RE: **2-ZN-2024**

Artessa

Planning & Development Services has completed review of the above referenced development application. The following comments represent issues or deficiencies identified by the review team and are intended to provide you with guidance for compliance with city codes, policies, and guidelines.

ARTESSA PINNACLE PEAK
PROPOSED CONDITIONS DRAINAGE AREA MAP

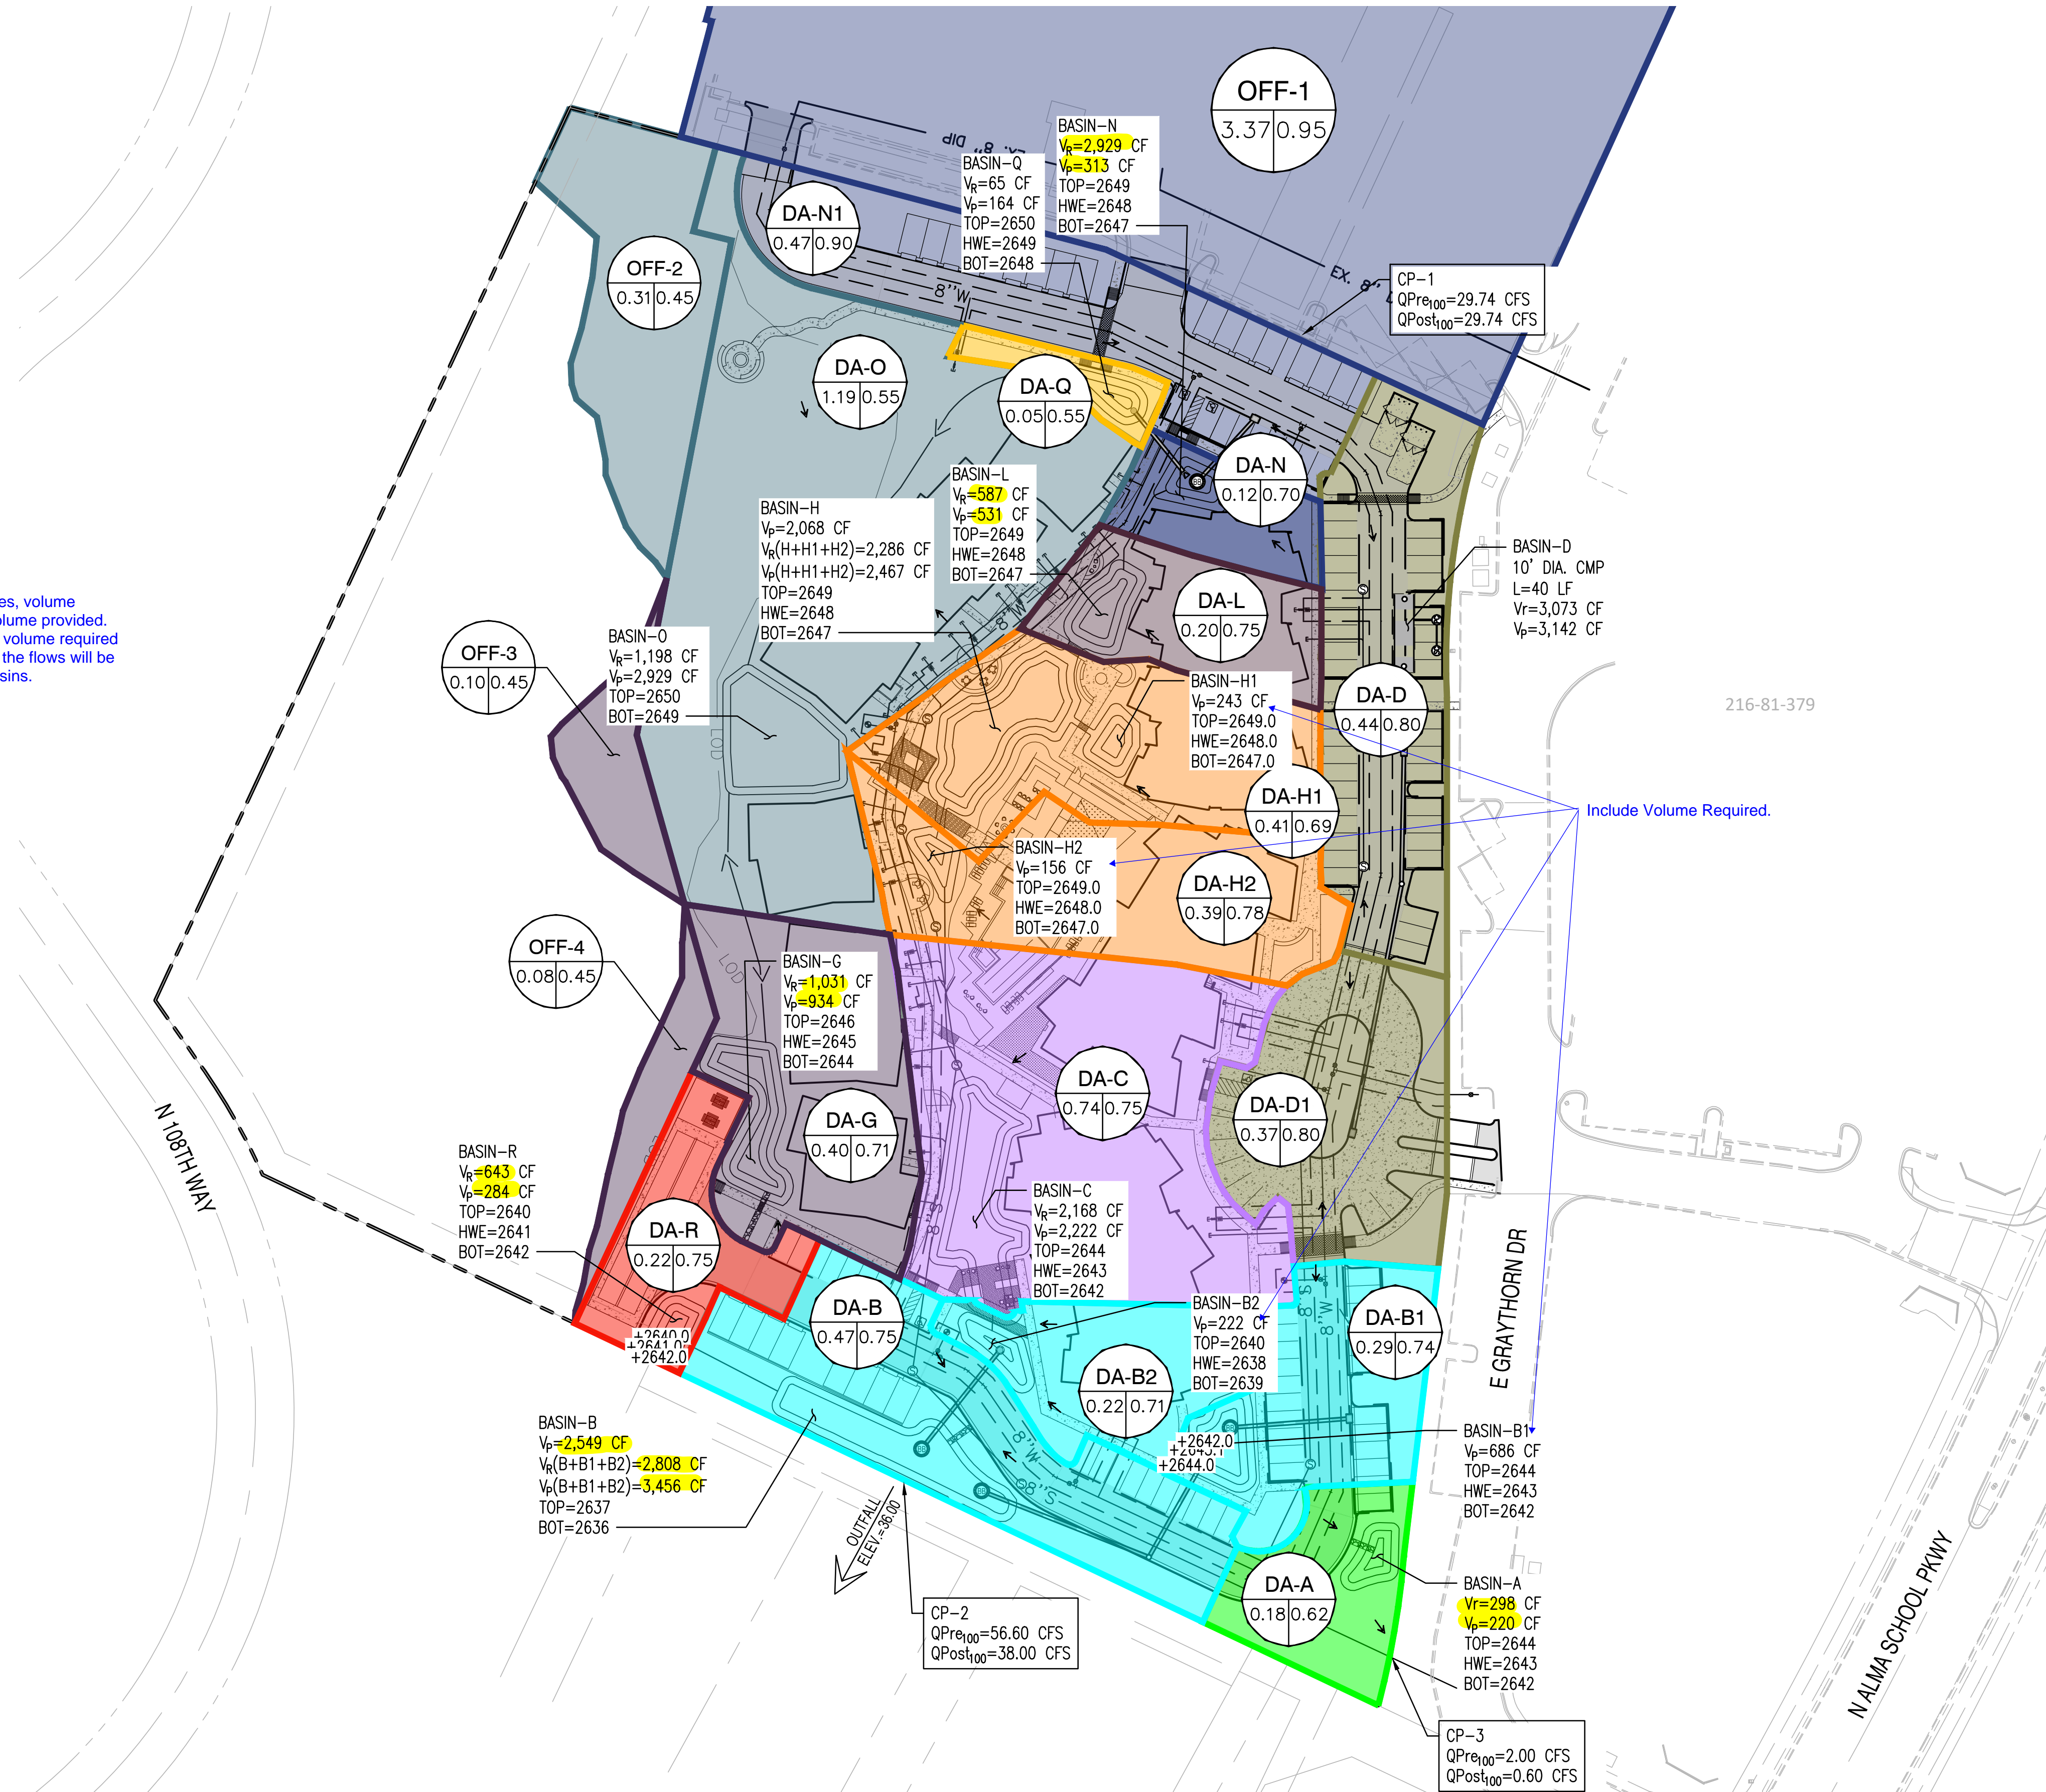
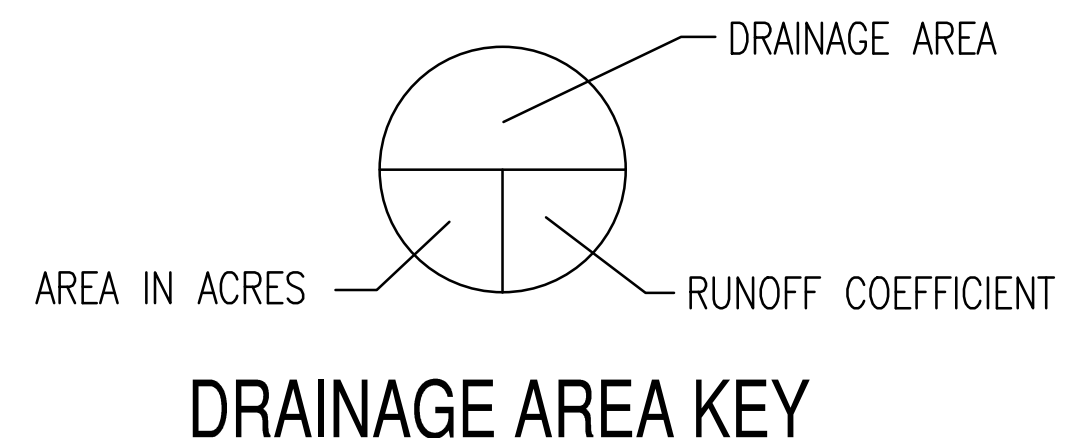
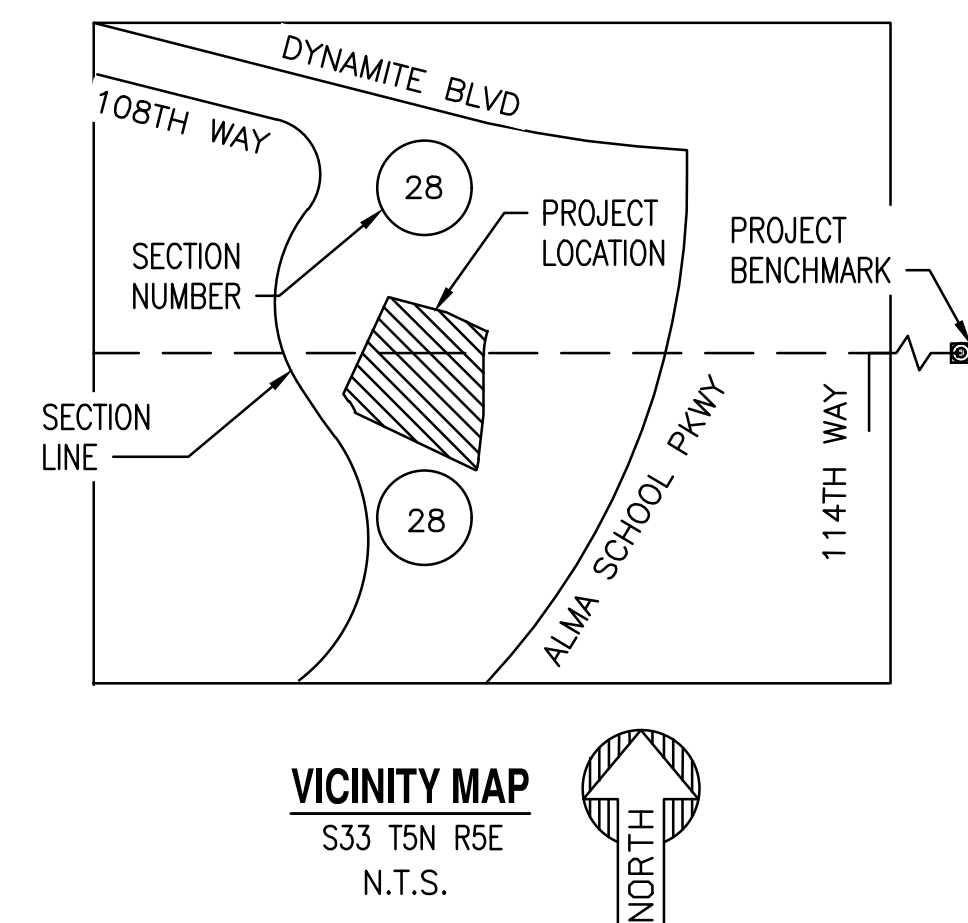
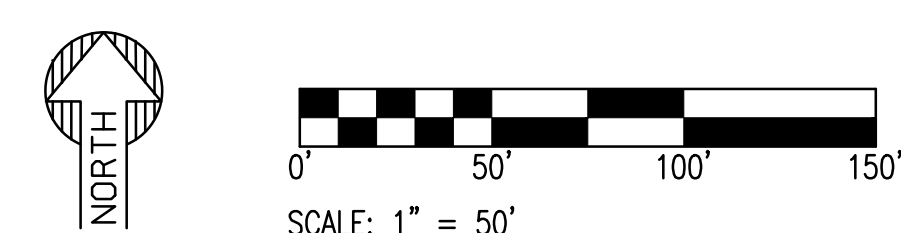
For highlighted values, volume
required exceeds volume provided.
Revise to ensure all volume required
is provided and that the flows will be
able to reach the basins.

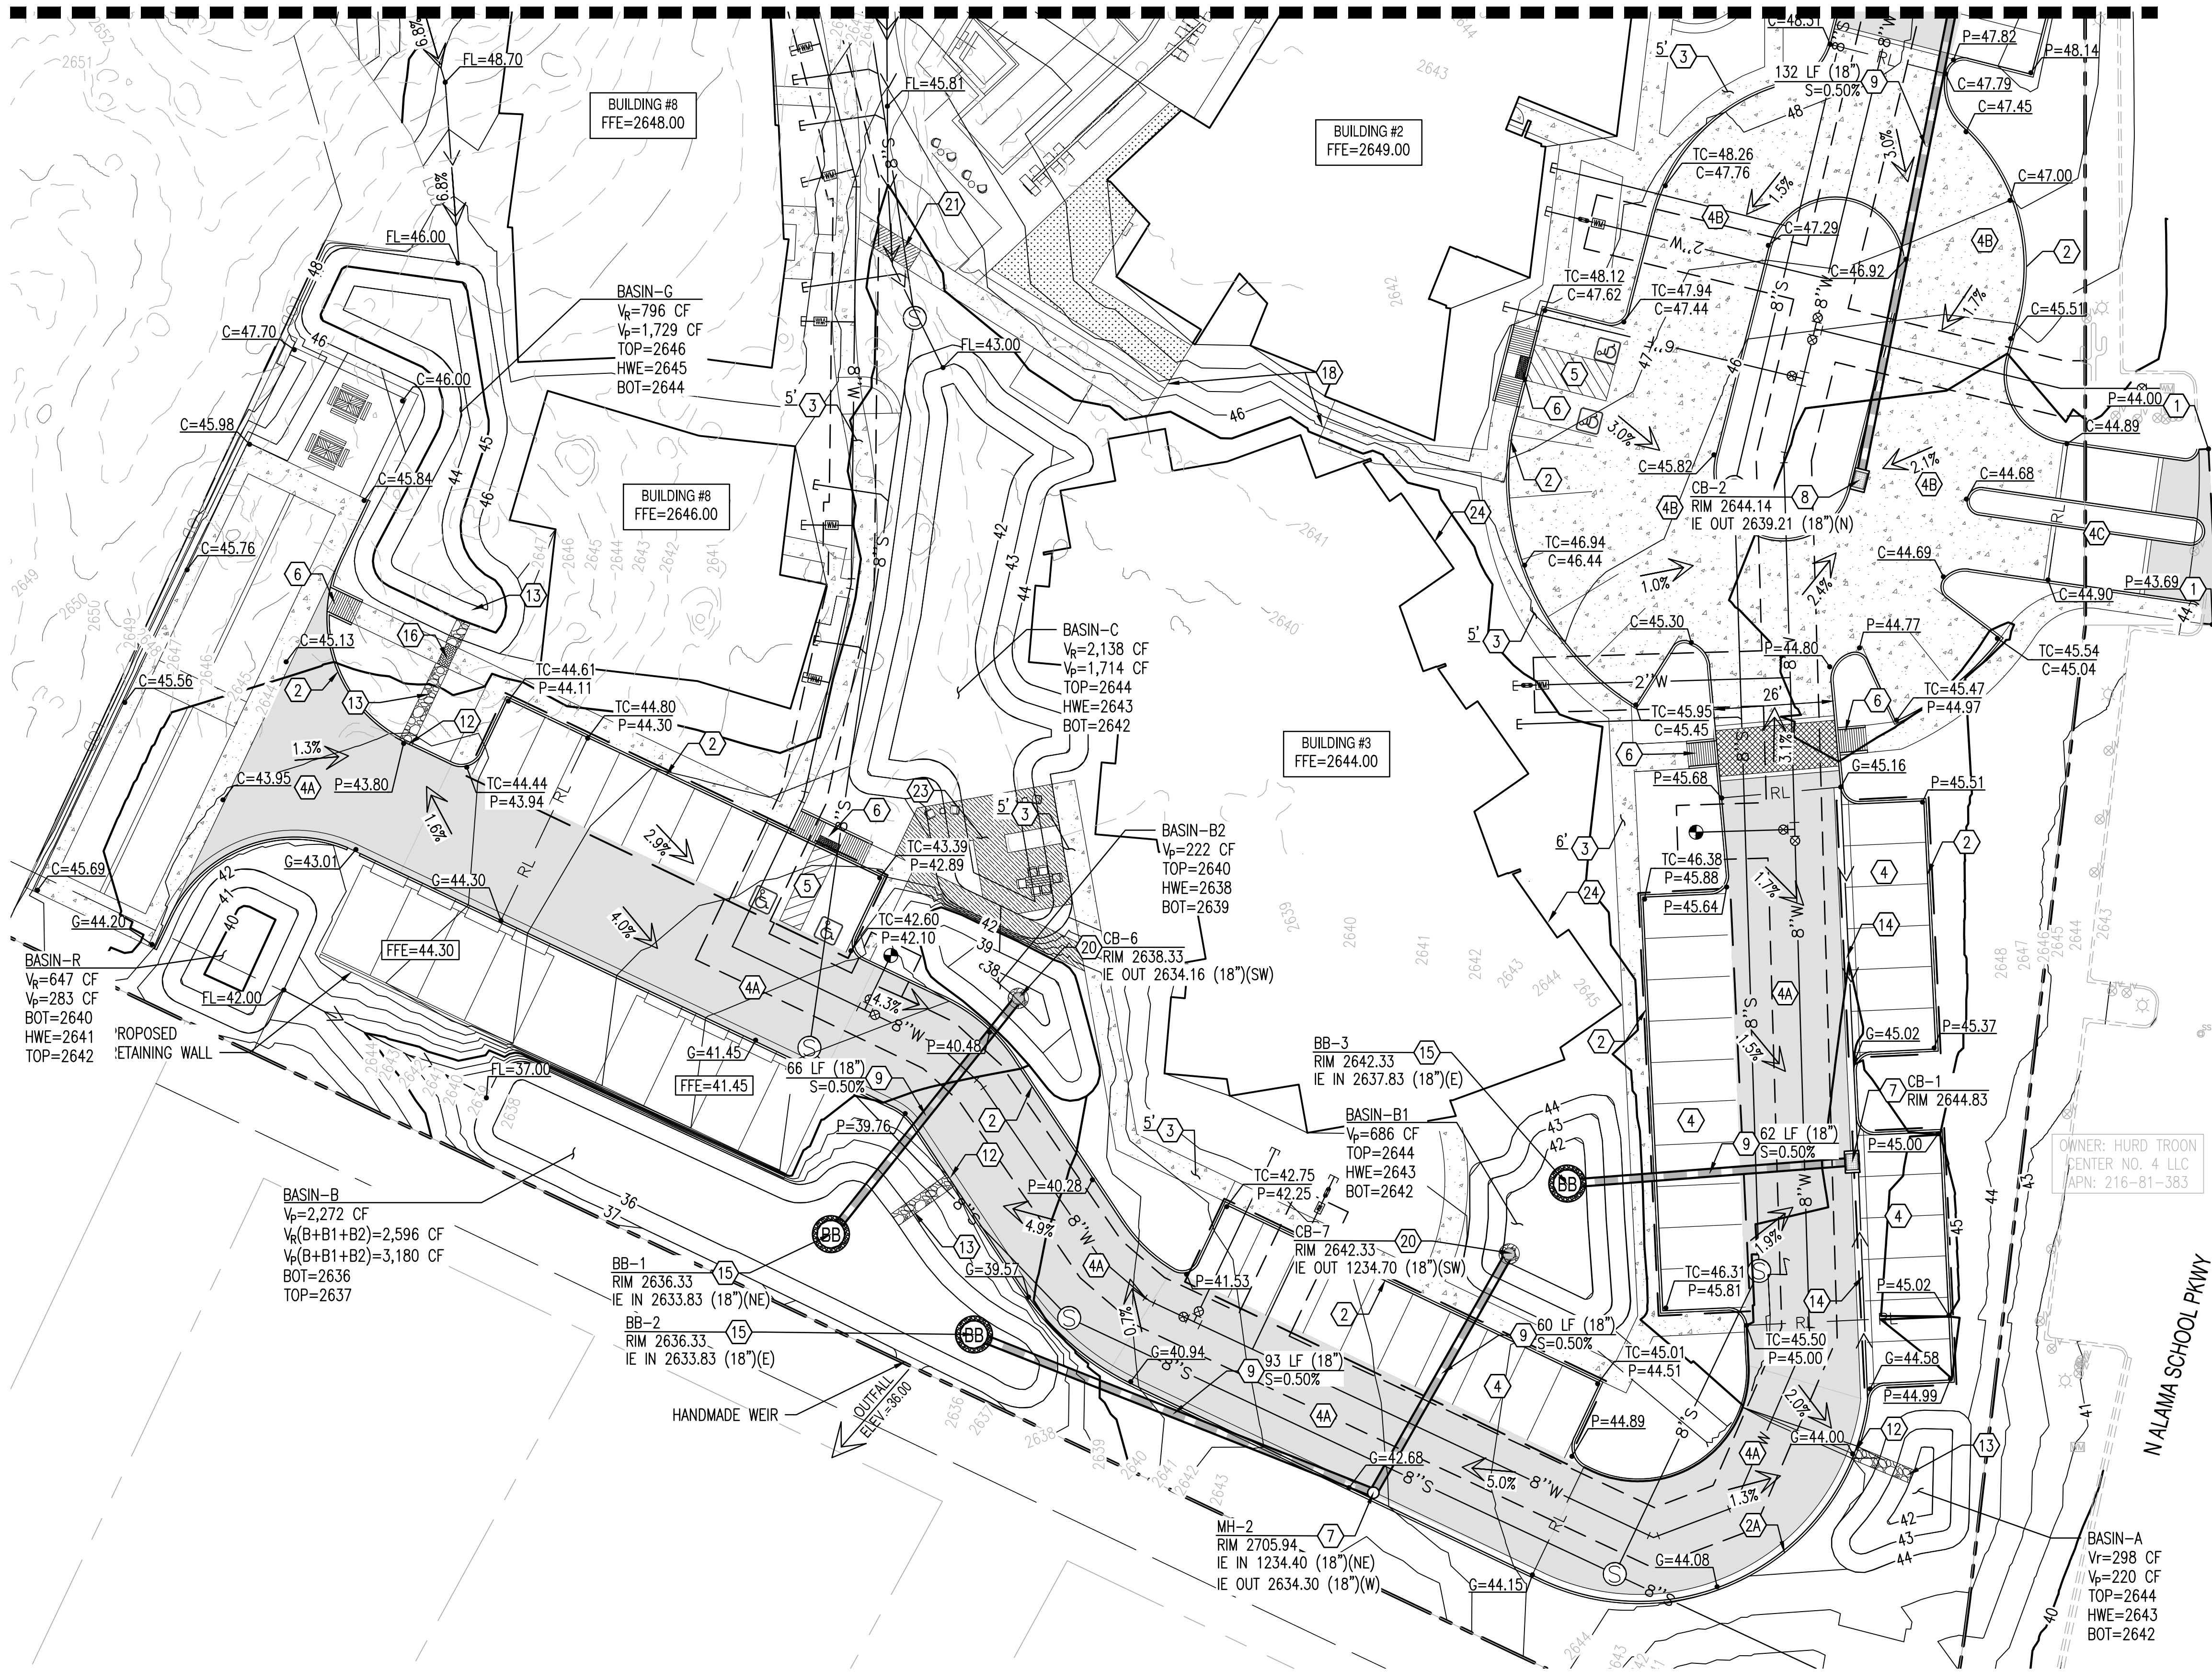
Revise per comments on Proposed Conditions Drainage Area Map.
